Object: Isobar TTL - Module In polyaxial screws recall notification

References: 12VTLPXX-XX -inner nut polyaxial screws

Letter Ref.: **Recall_12VTLP_062009**

Isobar™ TTL – Module In

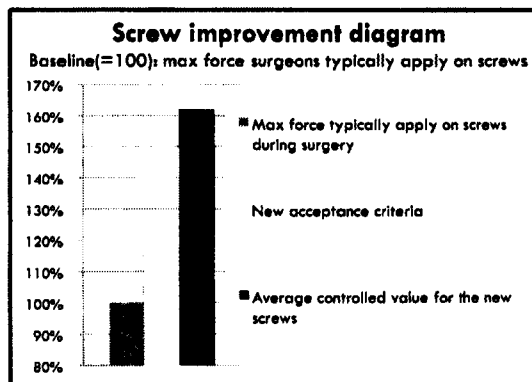
The poly axial screw is composed of 3 parts: the tulip head, the bone screw and the washer that locks the head mobility once the construct has been tightened by the set screw. In order to maintain this washer in place, a **caulking process** has been designed. The only function of the caulking is to maintain the washer in the tulip head before and during the surgery (prior to inserting the rod). After the surgery, the position of the washer is maintained by the rod and the set screw. The status of the caulking has no effect postoperatively on the mechanical integrity of the pedicle screw and durability of the construct.

In all cases, **inappropriate use** of the screwdriver (22TRV31) was the root-cause of the disassembly. Scient'x has validated a **significantly improved manufacturing process** that produces a caulking the strength of which **exceeds by far** the maximum force surgeons typically apply to the screw head during surgery. Nevertheless, under no circumstances should the insertion screwdriver (22TRV31) be utilized for removing or repositioning a poly axial screw (as stated in the Product Bulletin #001 and the new surgical technique).

As stated in the regulatory communication, a list of screw lot numbers should be sent back to Scient'x. In order to easily identify the new screws that will be shipped to the field, an additional laser marked character has been placed on the tulip head. Specifically, we have added a dark dot to the right of the "X" logo. Additionally, all new screws will have new lot numbers.
